**ADDENDUM TO VISUAL IMPACT ASSESSMENT
REDEVELOPMENT OF UNSW CLIFFBROOK CAMPUS, 45-51 BEACH STREET, COOGEE
STATE SIGNIFICANT DEVELOPMENT APPLICATION (SSD 8126)**

19 / 09 / 2017

Prepared for The University of New South Wales
Job number 16177
Date created 10 / 07 / 2017

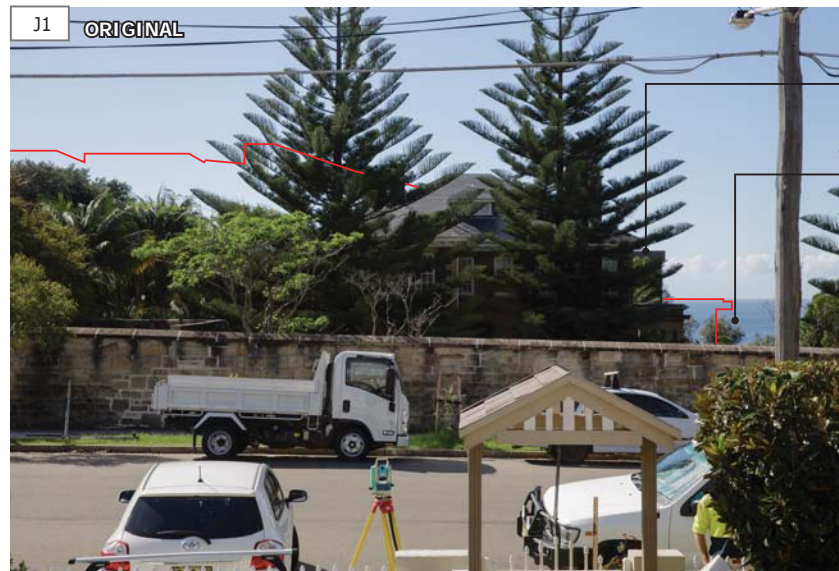
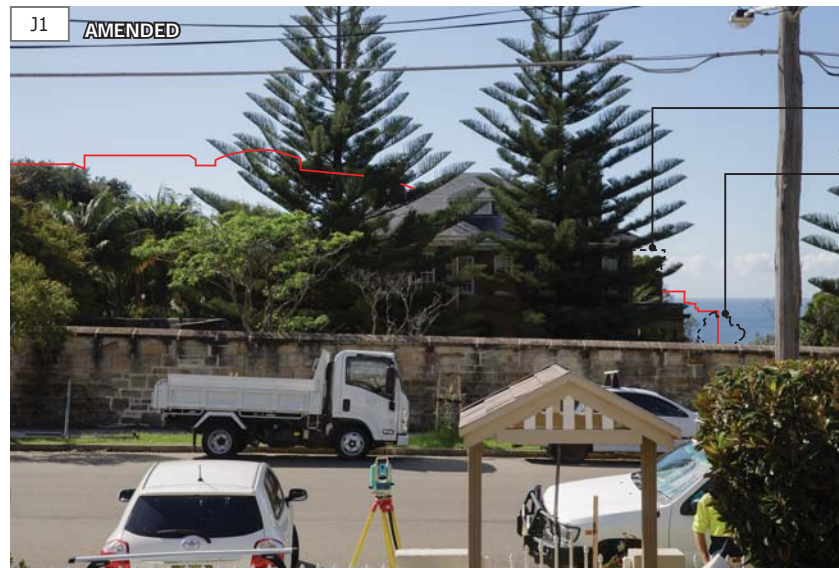
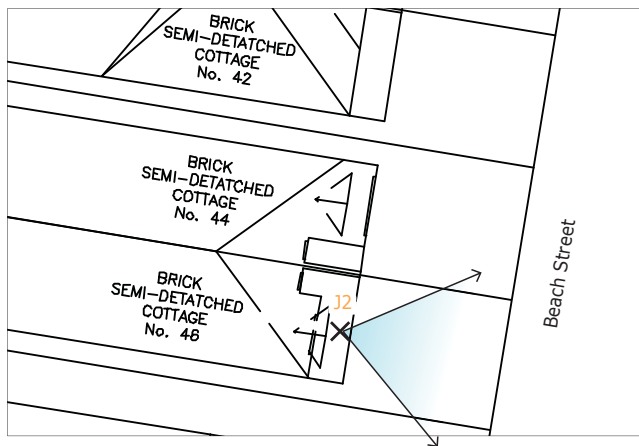
The amended proposal has a similar level of visibility as the original scheme due to the proximity to the viewer. In the original VIA report, GMU considered the proposal to have a significant level of impact on this view due to the potential obstruction of existing ocean views, but the impacts were considered to be potentially acceptable if GMU's recommended design changes were implemented.

As the amended view shows, the visual outcome of the proposal has noticeably improved after the mitigation measures have been implemented. On the left hand side of the view, the visible part of the proposal above the tree canopies has reduced. A greater improvement to the ocean view corridor can be seen on the right hand side of the view.

The original scheme obstructed approximately 50% of the horizon line. By lowering the height of the lounge area and redesigning the roof form of the east wing, the proposal is able to retain approximately 80% of the horizon line. Although a very small portion of the ocean would still be obstructed by the new building, the removal of an existing tree as part of the project would allow the resident at 44-46 Beach St to regain approximately an equal amount of ocean views. Furthermore, the demolition of the CC4 building would slightly increase sky views for the existing residents.

Outline of original proposal overlaid (in red) to show potential view changes

CC4 building to be demolished.

An existing tree to be removed.

Outline of amended proposal overlaid (in red) to show the improved outcome

Demolition of CC4 building would increase sky views.

Removal of an existing tree would increase water views.

Overall, GMU considers that the outcome has noticeably improved and the design is consistent with the *Tenacity* view sharing principles. The view impacts have been reduced from 'significant' to 'minor-moderate' and the visual impact is considered acceptable. The amendments lead to an improved outcome and, therefore, no further design changes are required.

Significance: Medium
 Visibility: Medium
 Impact: Minor-moderate

Acceptable, no further changes required

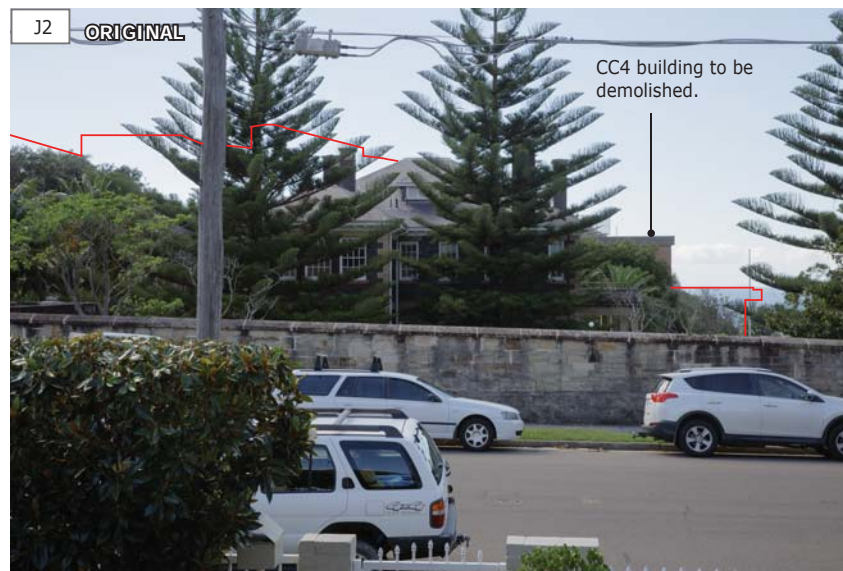
The amended proposal has largely the same level of visibility as the original scheme. In the original VIA report, GMU considered the proposal to have a significant level of impact on this view due to the partial obstruction of existing ocean views, but the impacts were considered to be potentially acceptable if GMU's recommended design changes were implemented.

As the amended view shows, the visual outcome of the amended proposal has noticeably improved. On the left hand side of the view, the visible part of the proposal above the tree canopies has reduced. On the right hand side of the view, the proposal demonstrates a noticeable improvement in terms of retention of existing ocean views.

The original scheme obstructed the horizon line and approximately 80% of the ocean views. By lowering the lounge area and redesigning the roof form of the east wing, the proposal is able to fully retain views of the horizon line and retain the majority of the ocean glimpses. The new building would still slightly reduce the lower part of the water views, but the affectation is limited to the area behind existing vegetation. The most valuable part of the water glimpses can be fully retained in this view corridor. The demolition of the CC4 building would also increase sky views for the existing residents.

Outline of original proposal overlaid (in red) to show potential view changes

Outline of amended proposal overlaid (in red) to show the improved outcome

Demolition of CC4 building would increase sky views.

GMU considers that the outcome has noticeably improved and the design is consistent with the *Tenacity* view sharing principles. The view impacts have been reduced from 'significant' to 'moderate' and the visual impact is considered acceptable. The amendments lead to improved outcome and, therefore, no further design changes are required.

Significance: Medium
 Visibility: Medium
 Impact: Moderate

Acceptable, no further changes required

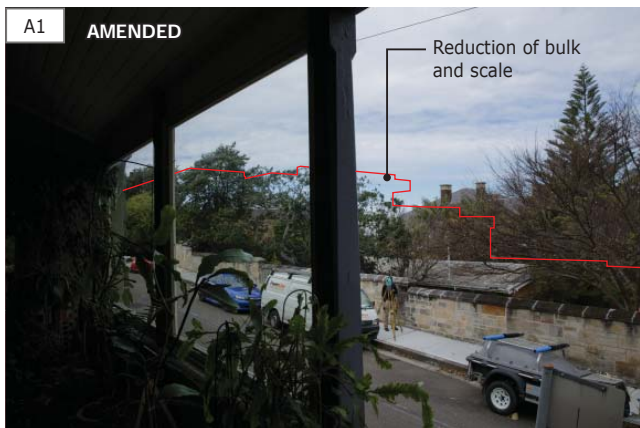
Comments: "The bulk of the building on Level 3 running along Battery Street will impose view and light restrictions on our property." "Please can we respectfully request that the length of Level 3 is shortened for the portion immediately across the road from our entrance. (Currently our front door entrance and lobby and our upstairs view from our lounge room which is at the front of our property is overshadowed by the highest part of this development)."

Response: The applicant has amended the design by reducing the plant room and stairs on the roof level. As the following photomontages show, the amendments further alleviate the visual impact of the development. The montage also shows that further shortening of Level 3 would not provide meaningful retention of any important view elements. Therefore, GMU considers that further changes to Level 3 are not required.
